Table 162C-3 MDI connector contact mapping GND clarification

Kent Lusted, Intel

Table 162C-3 MDI Connector Contact Mapping (in D3.0)

OSFP Connector (For Reference)

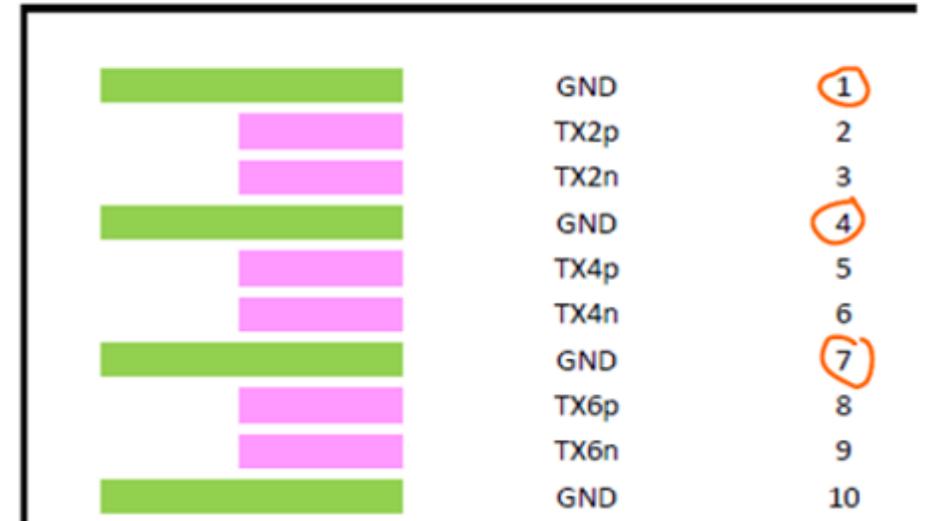
- For the OSFP TX2n/TX2p pair, note that GND pin #1 is closest to **TX2p** and GND pin #4 is closest to **TX2n**. Also, GND pin #4 goes with **TX4p** and GND pin #7 goes with **TX4n**.

- The issue now comes from having both the OSFP and QSFP-DD800 pins in the same table.
 - For the QSFP-DD800 column, GND pin #1 is the physical pin next to SL1n (TX2n in the connector spec) and GND pin #4 is the physical pin next to SL1p (TX2p).
 - However, in the OSFP column, the physical GND pin next to SL1n (TX2n) is pin #4, not pin #1 as shown above, and the physical GND pin next to SL1p (TX2p) is pin #1, not #4.
- Then the table becomes very messy on subsequent rows because the GND pin number can be one of two values in the OSFP case; for example, GND pin #1 is next to SL1p (TX2p) but GND pin #7 is next to SL3n (TX4n).
- A similar issue exists for SFP/SFP-DD/DSFP

- The GND pins are useful information, keep them in the table(s)
- Replace Table 162C-3 with three tables:
 - QSFP/QSFP-DD800 table
 - OSFP table
 - SFP/SFP-DD/DSFP table
